# PRODUCT CHANGE NOTICE

1. TITLE <b>IR RADHard™ Power MOSFET / Performance Correction</b>		2. DOCUMENT NUMBER <b>FV5-C-12-001</b>
		3. DATE <b>December 19, 2011</b>
4. MANUFACTURER AND ADDRESS <b>International Rectifier</b>  <b>205 Crawford Street</b> <b>Leominster, MA 01453</b>		5. MANUFACTURER PART NUMBER <b>IRHNM57110, IRHNM53110, IRHNMC57110,</b> <b>IRHNMC53110</b>

ADDENDUM A  
**Safe Operating Area Curves**

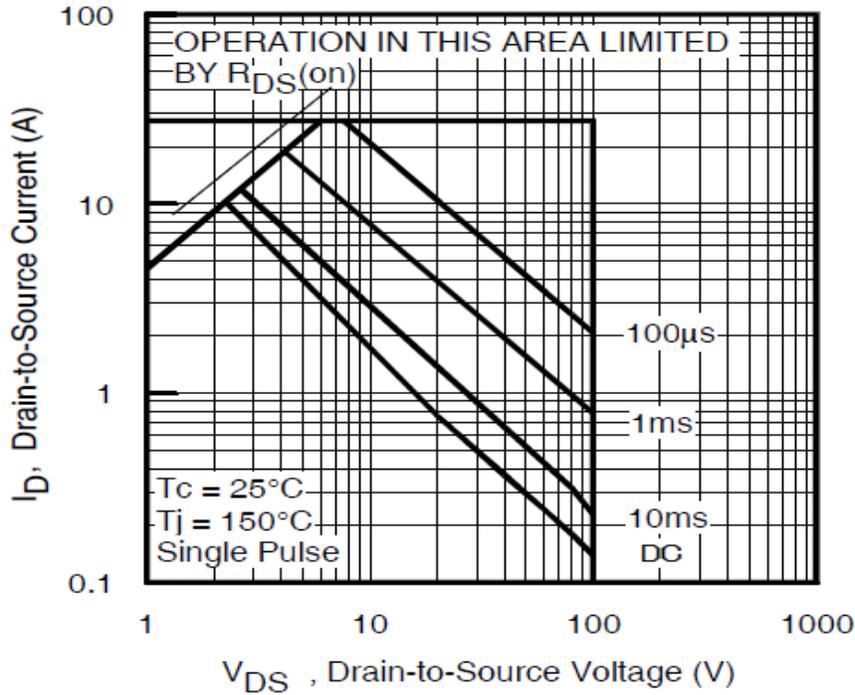
14. PRODUCT CHANGE  <p>This GIDEP PCN is to announce a specification change/correction of the SOA (Safe Operating Area) curve for the RADHard™ 100V, N-Channel Power MOSFET, IRHNM57110 base product, referenced in IR datasheet No. PD-97192. The change/correction to the SOA curve is made to match the performance that is specified in the equivalent MIL-PRF-19500/743B QPL datasheet. The original IR datasheet was rated at a higher SOA target than the QPL /743. Additional derating was added in QPL /743 for guardbanding.</p>  <p><b>SMD-0.2</b></p> <p><b>SOA (Safe Operating Area):</b> Refer to attached curves in Addendum A herein for change/correction detail.</p>
